**Overview:** The initial production release of the FTI-TLK1 harness has an issue where in some vehicles the secondary power input to the CN1 connector will overload the associated vehicle circuit, causing a fuse to blow. This issue affects the initial release of harnesses and is already being addressed in production. A field correction procedure is detailed below in Figure 1.

**Figure 1: Step by step adapter correction**

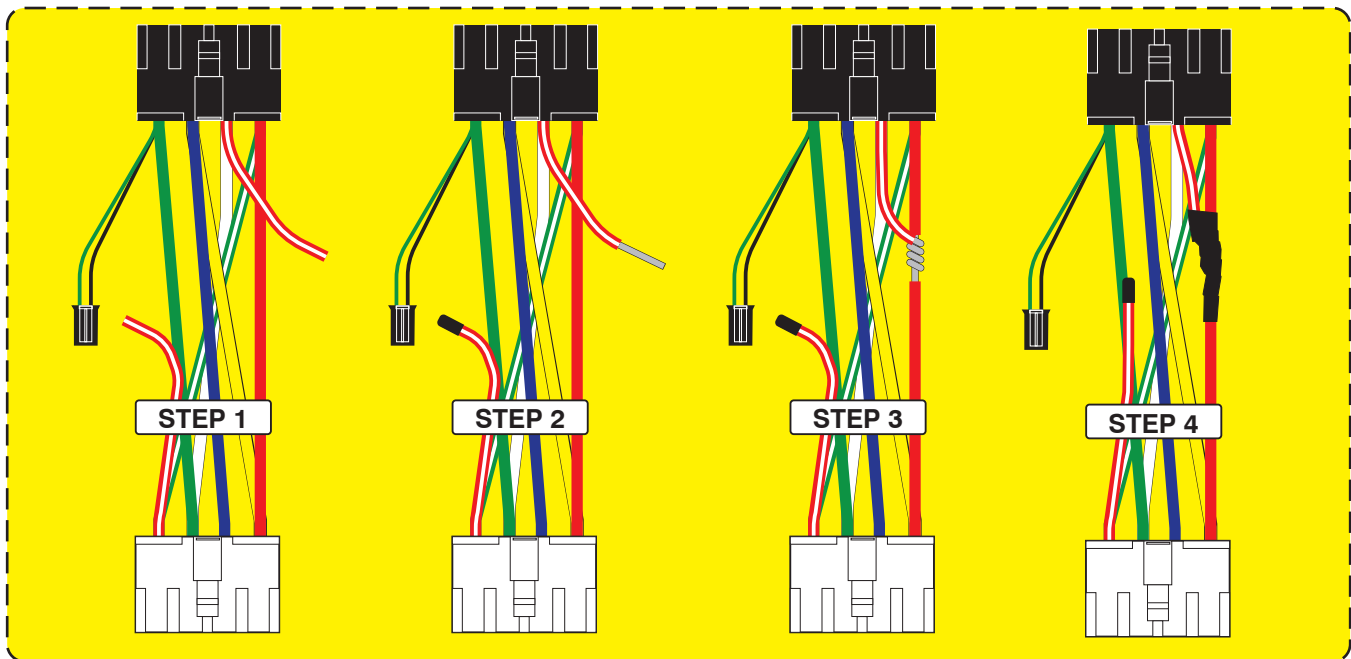
**Issue:** The secondary power circuit can overload some vehicle ignition switch circuits, causing a blown 5A/7.5A AM1 fuse, potentially disabling the vehicle and leaving the consumer stranded. Affected adapters are illustrated below in figure 2.

- 1.) Select the applicable CN1 adapter, isolate the RED/WHITE power wire, cut wire approximately 4" from the BLACK plug
- 2.) Insulate the wire still connected to the WHITE plug using heat shrink tubing, and strip the insulation on the other wire end
- 3.) Strip a portion of the insulation from the RED wire, attach the stripped RED/WHITE to the exposed RED wire, solder together
- 4.) Apply insulating tape to the soldered connection and secure the cut ends back to the bundle of wires created by the adapter
- 5.) Correction complete, you may safely proceed to finish your installation
